Re: Contra Costa Water District Comments on Bay Delta Conservation Plan and Draft EIR/EIS

Draft Bay Delta Conservation Plan and Accompanying
Draft Environmental Impact Report / Environmental Impact Statement

Contra Costa Water District
Comments on the December 13, 2013
Draft Bay Delta Conservation Plan and Accompanying Draft EIR/EIS

Figure 1-1. Effect of tidal marsh restoration on Delta salinity depends on location of proposed tidal marsh and connectivity to the channels.

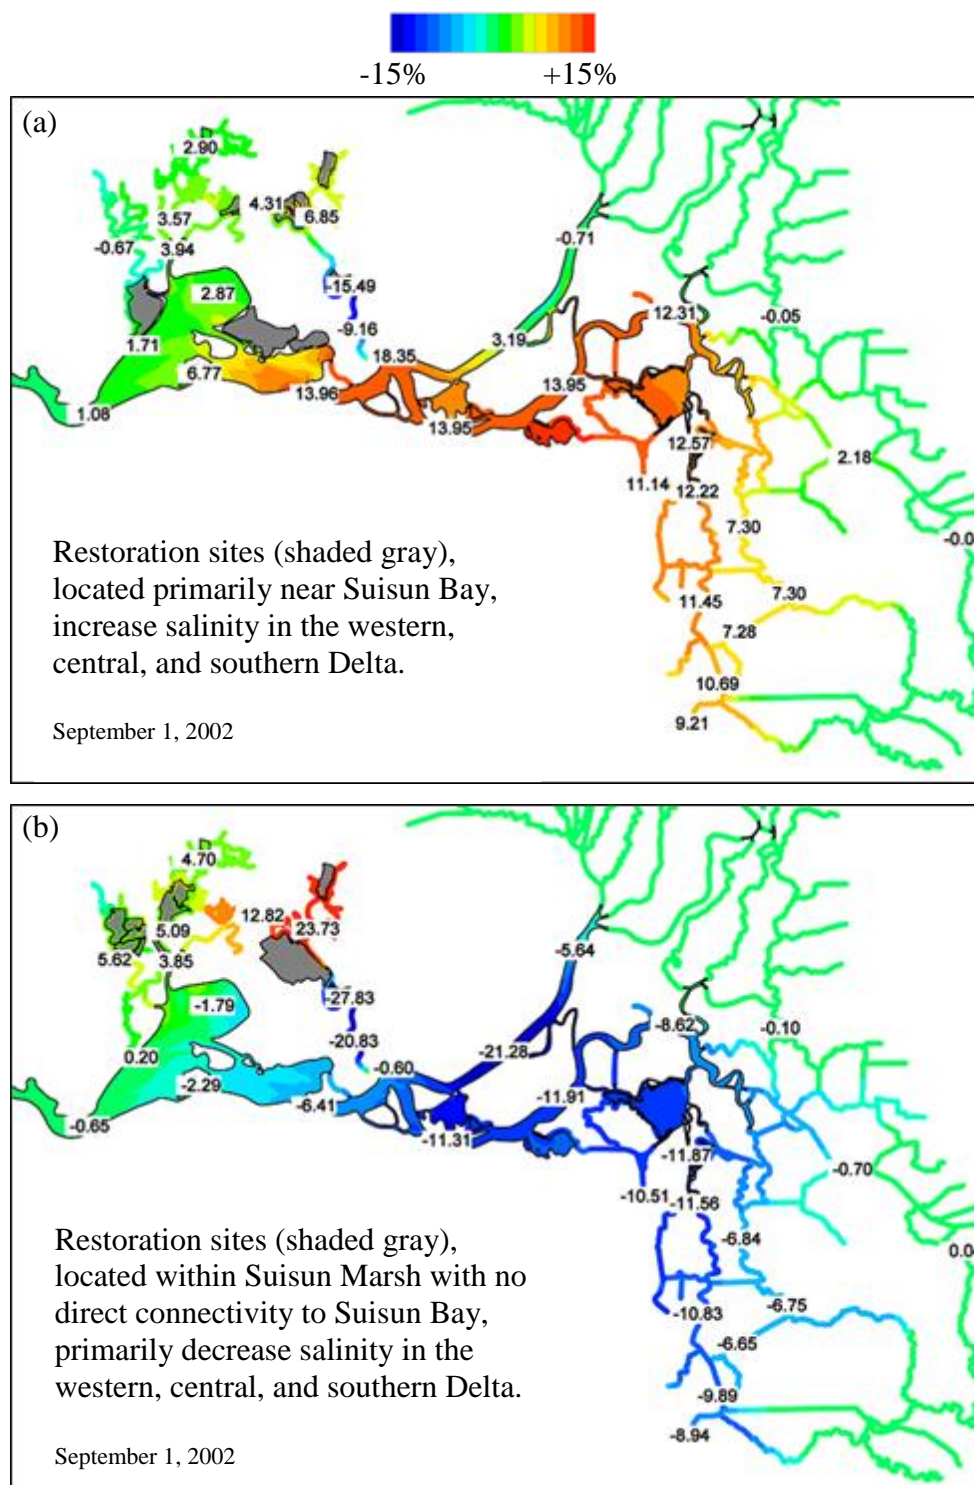
Location and connectivity. The location of proposed tidal marsh and its connectivity to the existing Delta channels have a large effect on the movement of water and mixing of water quality constituents, such as salt. For instance, analysis of two different groups of restoration sites in Suisun Marsh reveals dramatically different changes to salinity in the Delta (RMA, 2013). As shown in Figure 1-1 (panel (a) – top map), the group of restoration sites located primarily adjacent to Suisun Bay would ***increase salinity*** in the western, central, and southern Delta, generally by 10 to 15 percent (top map). On the other hand, as shown in Figure 1-1 (panel (b) – bottom map), the group of restoration sites located farther north in Suisun Marsh, with no direct connectivity to Suisun Bay, would ***decrease salinity*** in the same region on the same day, generally by 10 to 20 percent.

Delta waters are colored by the percent change in salinity due to tidal marsh restoration at sites in Suisun Marsh, shaded gray in the maps below

Figure 1-2. Potential benefits and impacts of restoration at Prospect Island depend on design elements regarding the connectivity of the interior island to the surrounding channels.

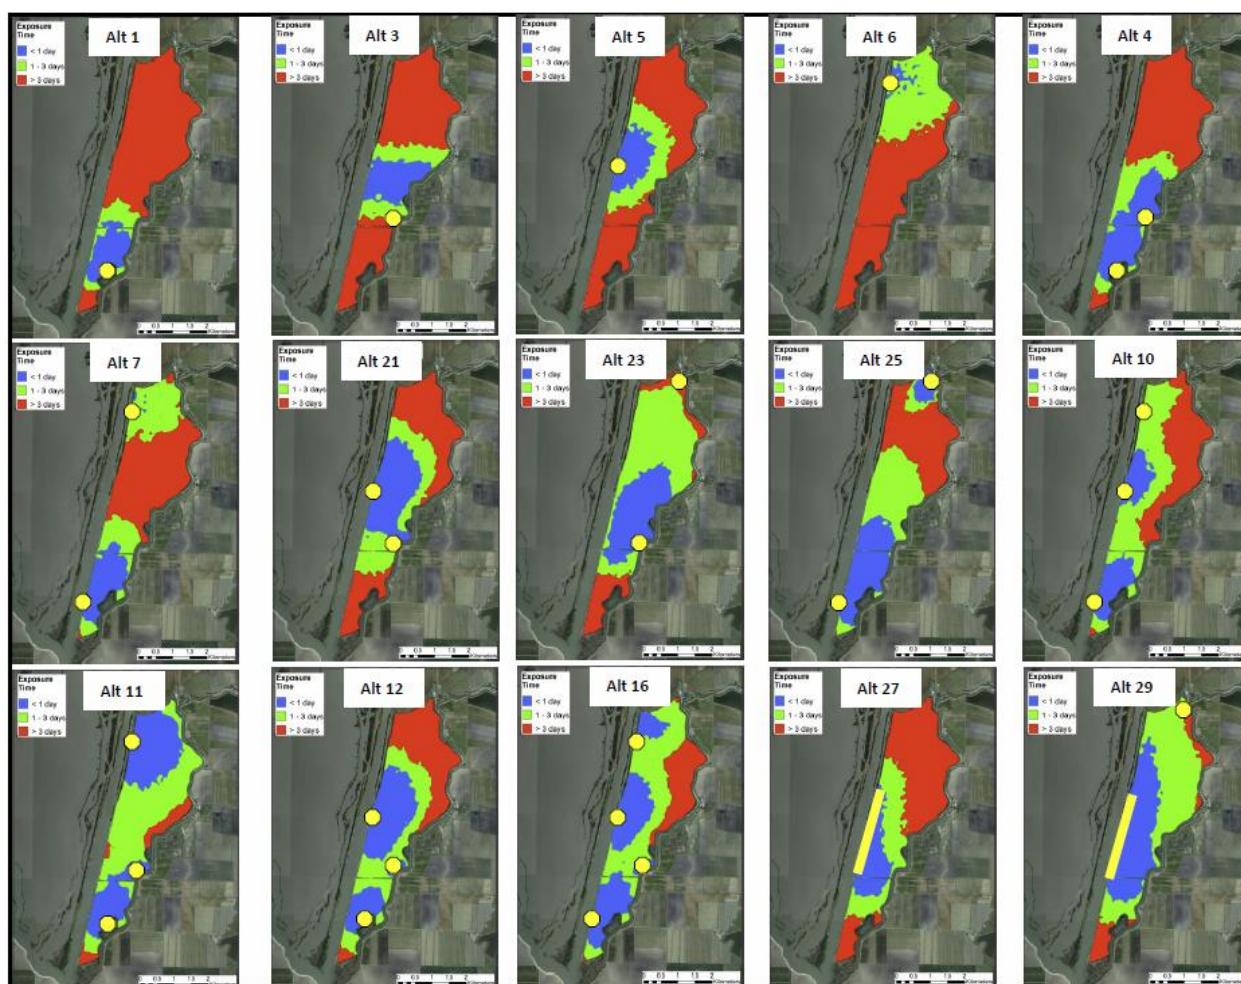
During screening level analysis, fifteen alternatives were evaluated to determine the potential to maximize food web productivity within the restoration site. The only difference between the alternatives was the location and size of breaches in the levees that surround Prospect Island and in a levee inside Prospect Island (RMA, 2013). The modeling results are presented in Figure 1-2, which depicts the areas of the restoration site as colored to show the type of algal community that would be likely to grow based on the simulated exposure time. As shown in Figure 1-2, the acreage that would be likely to produce benefits and the acreage that would be likely to produce adverse impacts varies widely between the alternatives that were studied. Although the focus of the analysis was the potential adverse or beneficial impact on covered fish, the production of different algal communities would also impact drinking water quality, as discussed in Section 2.2.1.2 of these comments.

Waters within Prospect Island, a possible restoration site, colored by the potential to produce adverse or beneficial algal communities for different design criteria

Figure 1-3. Prospect Island and Liberty Island during a high outflow event illustrating (a) turbidity and (b) change in turbidity for two different habitat restoration alternatives on Prospect Island.

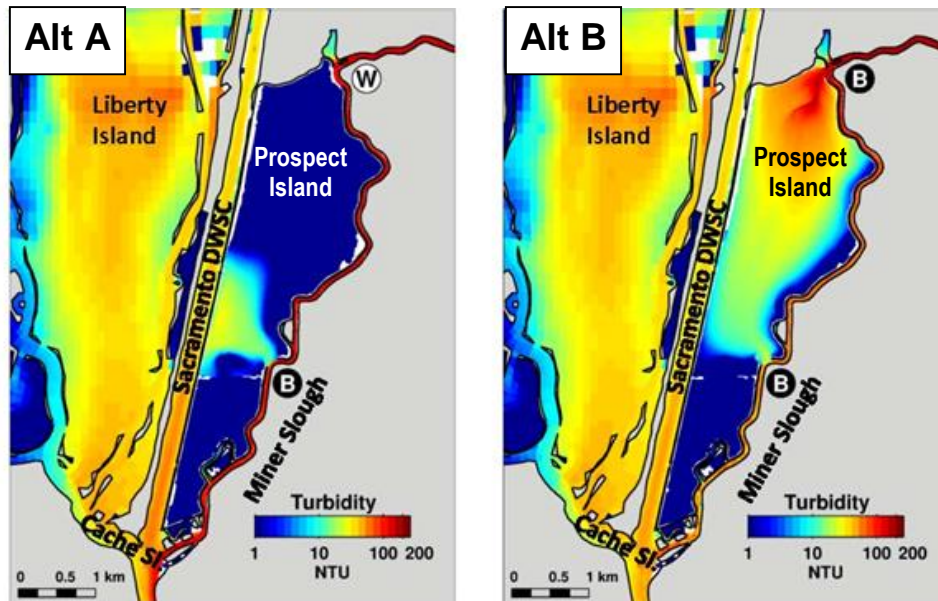
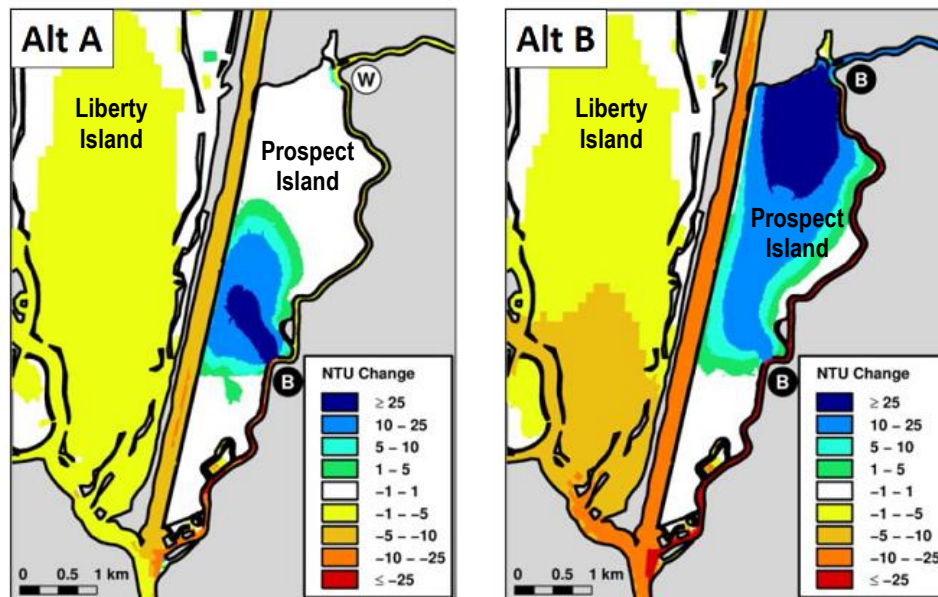
A more recent analysis of the Prospect Island Tidal Habitat Restoration Project evaluated the changes in turbidity that could result from a relatively minor change in the type of levee breach (MacWilliams et al., 2014). One of the alternatives in this analysis (Alternative A) would have a weir at the north of the island, while another alternative (Alternative B) would have a breach in the levee at the same location in the north end of the island. Thus, the difference between the two alternatives is the size of the connection between the restoration site and the adjacent channel. As shown in the first panel of Figure 1-3 below (panel (a)), turbidity under Alternative A would be up to 200 times lower in the north of the island than under Alternative B for the exact same flow conditions. Furthermore, as shown in the second panel of Figure 1-3 below (panel (b)), the change in turbidity due to the restoration action would extend outside of the restoration site. Although both alternatives would reduce turbidity in the region, Alternative B would have a much greater effect, reducing turbidity in the Deep Water Ship Channel by 10 to 25 nephelometric turbidity units (NTU) and reducing turbidity in lower Liberty Island by 5 to 10 NTU.

Additionally, the shape of the restoration site in relation to the dominant wind direction, the ground elevation, channel design, vegetation type, and relation to other restoration projects in the Delta all have a significant influence over the flows and water quality in the region. For example, in Mildred Island (which flooded in 1983, creating tidal habitat), the southeast corner of the habitat experiences the highest productivity due to the lack of flushing by tides and freshwater flows; yet when the dominant wind direction shifts, the area can be flushed, forcing exchange with nearby areas (Serenio et al., 2003). In Franks Tract, growth of submerged water weeds from the spring through early fall effectively channelizes the open water area. In late summer and fall when the weeds fill the full water column, residence time is increased within the vegetation and greatly reduced within the open water areas, with limited mixing between the regions (Serenio and Stacey, 2004). Due to the longer residence time and limited mixing, waters within the vegetation are warmer than the adjacent open water, and as salinity intrudes during the fall, salinity in the open water areas is greater than it would be without the vegetation.

Figure 2-1. Drinking Water Intakes in the Delta.

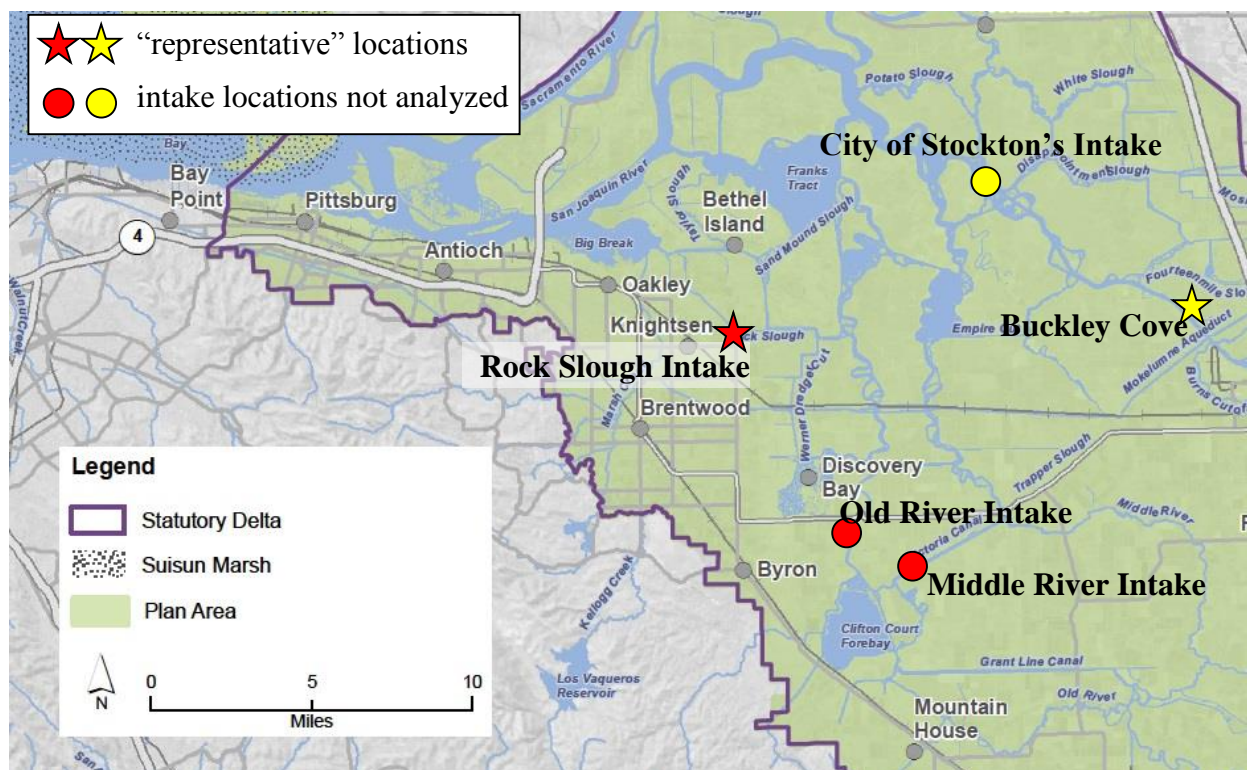
The BDCP Draft EIR/EIS inappropriately assumes that water quality at one location is representative of other locations, stating “[f]or municipal intakes located in the Delta interior, assessment locations at Contra Costa Pumping Plant No. 1 and Rock Slough are taken as representative of Contra Costa’s intakes at Rock Slough, Old River and Victoria Canal, and the assessment location at Buckley Cove is taken as representative of the City of Stockton’s intake on the San Joaquin River.” BDCP Draft EIR/EIS, Chap. 8 at pp. 8-149 and 8-162. This assumption is unreasonable. The actual intakes and their “representative” locations are up to 17 river miles apart (Figure 2-1). Hydrodynamic and water quality conditions vary widely within the Delta; indeed, it is the difference in salinity at different locations in the Delta interior that drove CCWD’s construction of its Old River intake and Middle River intake on Victoria Canal (collectively “Old and Middle River intakes”). Even intakes that are relatively close together such as CCWD’s Old and Middle River intakes have very different water quality because of the complexity of the hydrodynamics in the Delta (CCWD and Reclamation, 2006, Exhibit ES-2 at p. ES-5).

In fact, the differences in the quality of water at the “representative” sites in comparison to the actual intake locations were readily available to the BDCP consultants because the modeling that was used as the basis for the BDCP Draft EIR/EIS analysis includes results for water quality constituents at both the “representative” sites and at the actual intake locations. This modeling was provided by the DWR to CCWD in 2013 (DWR, 2013b). Plots of salinity variation in time at each location illustrate that the “representative” sites are, in fact, not representative of the actual intake sites. For instance, in the No Action Alternative, the salinity at Buckley Cove is dramatically different than the salinity at the City of Stockton’s intake (Figure 2-2). Similarly, in the No Action Alternative, salinity at the Rock Slough intake would at times be up to 800 microsiemens per centimeter greater than salinity at the Middle River intake; while at other times, salinity at the Middle River intake would be up to 200 microsiemens per centimeter greater than at the Rock Slough intake (Figure 2-3); neither the seasonal pattern nor the annual maximum and minimum values of salinity coincide temporally at these sites. Given the differences in salinity under the No Action Alternative between the “representative” sites and the actual intake locations,

it is not appropriate to use the “representative” sites to assess impacts at drinking water intakes when modeling results for the actual intake sites are readily available.

Figure 2-2. Salinity at the City of Stockton’s intake and Buckley Cove

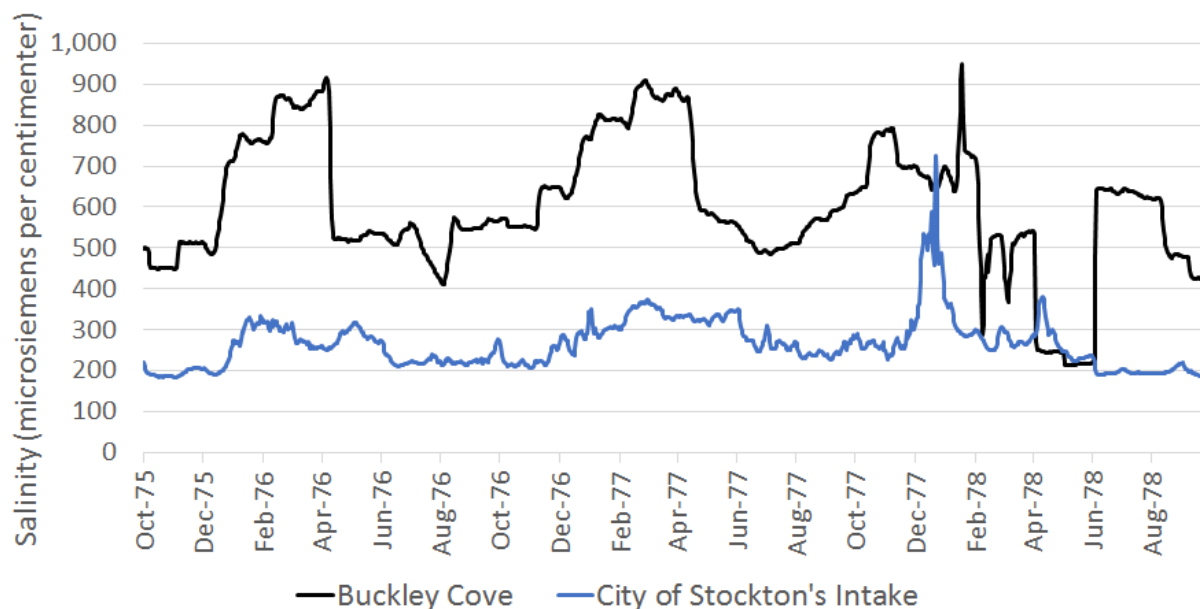
Results from modeling of the No Action Alternative, performed for BDCP Draft EIR/EIS and provided to CCWD by DWR (DWR, 2013b), illustrate that salinity at the City of Stockton’s intake differs significantly from salinity at the Buckley Cove. The quality of water at the Buckley Cove is not representative of the City of Stockton’s intake.

Figure 2-3. Salinity at CCWD’s Rock Slough, Old River, and Middle River intakes

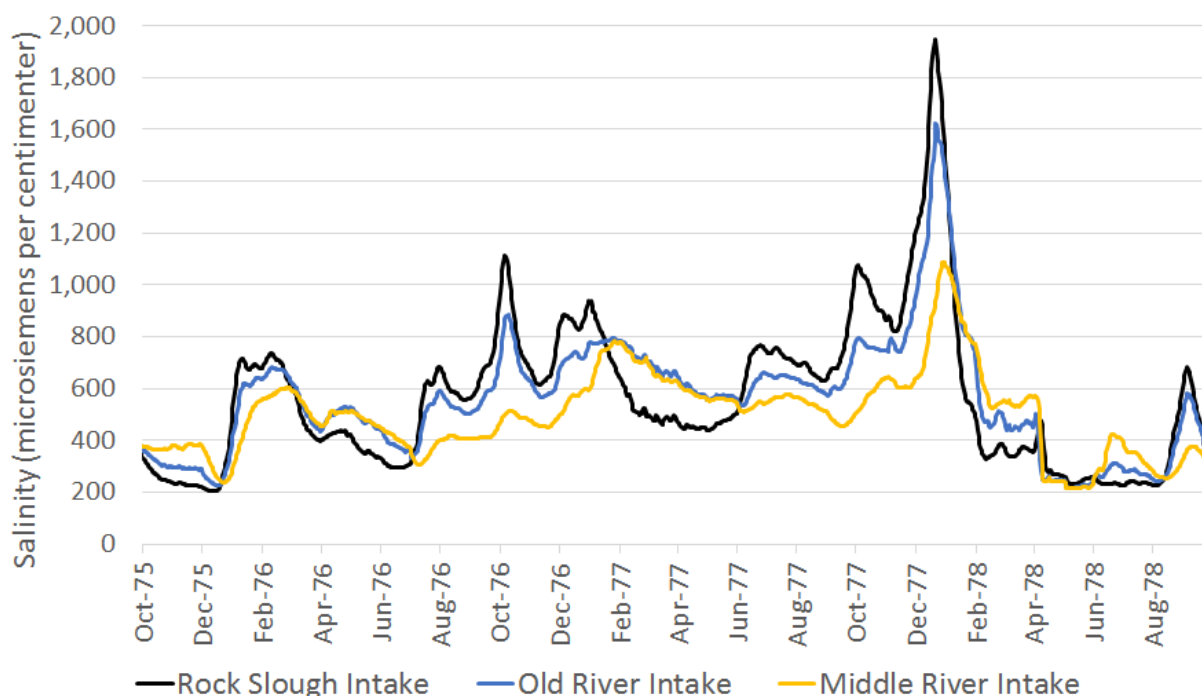
Results from modeling of the No Action Alternative, performed for BDCP Draft EIR/EIS and provided to CCWD by DWR (DWR, 2013b), illustrate that salinity at the Rock Slough intake differs significantly from salinity at the Old River intake and Middle River intake. The quality of water at the Rock Slough intake is not representative of the other two intakes.

The differences in the quality of water at different locations in the Delta interior is partially due to the difference in the source of the water. For instance, some locations within the Delta interior are dominated by water that originated on the Sacramento River, while other locations are dominated by water from the San Joaquin River and still other locations are dominated by water from the Bay; the magnitude of local agricultural drainage also varies from place to place. The mixture varies spatially and temporally as river flows and tidal dynamics change throughout the seasons and between years. The modeling that was used as the basis for the BDCP Draft EIR/EIS analysis (DWR, 2013b) calculates the fraction of water that originates from the upstream rivers and the downstream bay at both the “representative” sites and at the actual intake locations. Plots of the percentage of water at each location that entered the Delta from the Sacramento River water illustrate that the “representative” sites are, in fact, not representative of the actual intake sites because the makeup of the water at each location is dramatically different. For instance, Figure 2-4 shows that the location of the City of Stockton’s intake often receives greater than 70% of its water from the Sacramento River, while Buckley Cove seldom receives any water from the Sacramento River.

Figure 2-4. Percent of water at the City of Stockton’s intake and Buckley Cove that originated on the Sacramento River

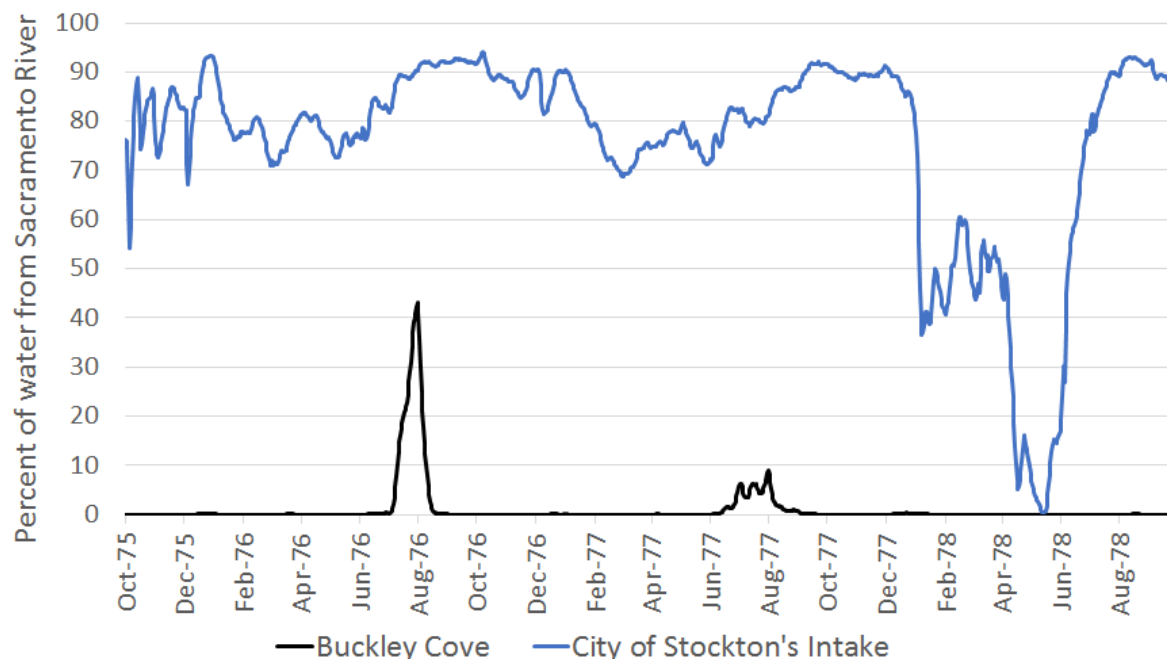
Since all of the BDCP alternatives propose either to divert Sacramento River water before it enters the central Delta (Alternatives 1 through 8) or to construct numerous barriers that would alter the mixing of river and bay waters (Alternative 9), the BDCP would impact the mixture of water at all locations within the interior Delta. Because of the complicated nature of the movement and mixing of waters within the Delta, the impact would vary by location. For this reason, it is not appropriate for the BDCP Draft EIR/EIS to use “representative” sites when information at actual intakes sites is readily available.

Results from modeling of the No Action Alternative, performed for BDCP Draft EIR/EIS and provided to CCWD by DWR, illustrate that the percent of water that originated on the Sacramento River varies dramatically between the City of Stockton’s intake and the “representative” site at Buckley Cove.

Figure 2-5. Impact to CCWD's delivered water quality

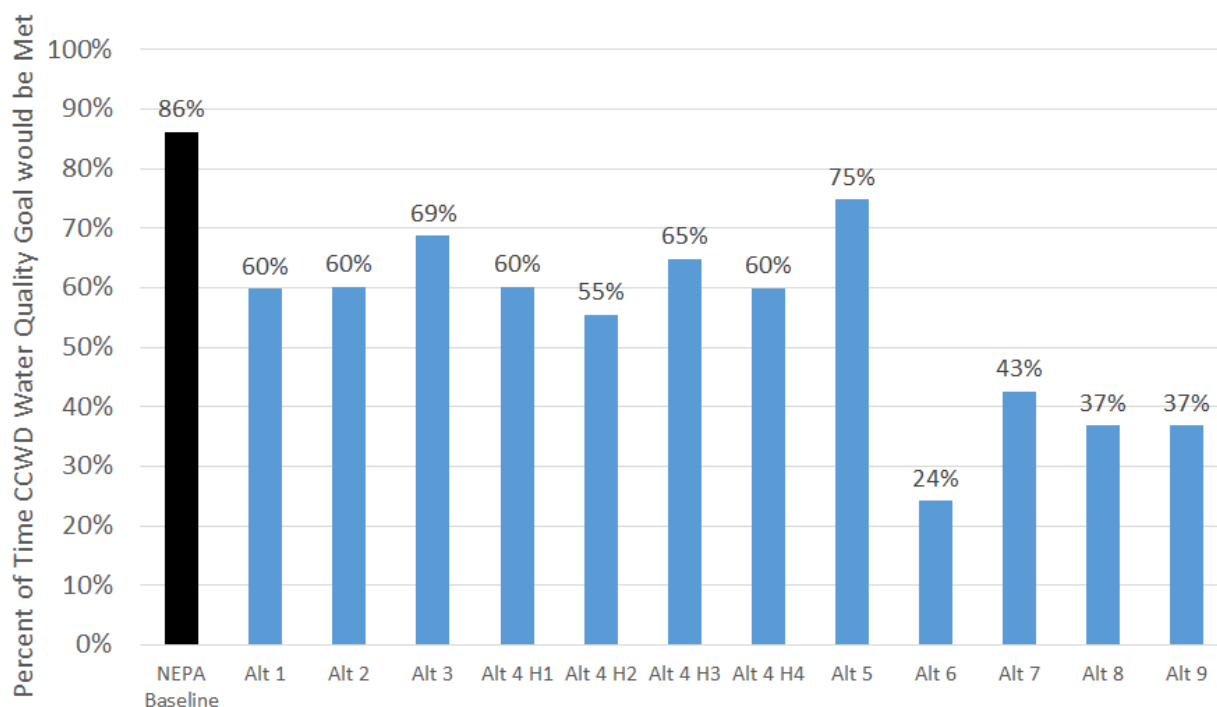
As illustrated in Figure 2-5, the percent of the time that CCWD could meet its water quality goal of 65 mg/L chloride concentration would be reduced in every alternative in comparison to the NEPA baseline.¹⁸ For instance, CCWD would be able to meet its water quality delivery goal 86% of the time under the No Action Alternative, but under Alternative 4 the delivery goal would be met only between 55% and 65% of the time, depending on the operational scenario (H1 through H4).
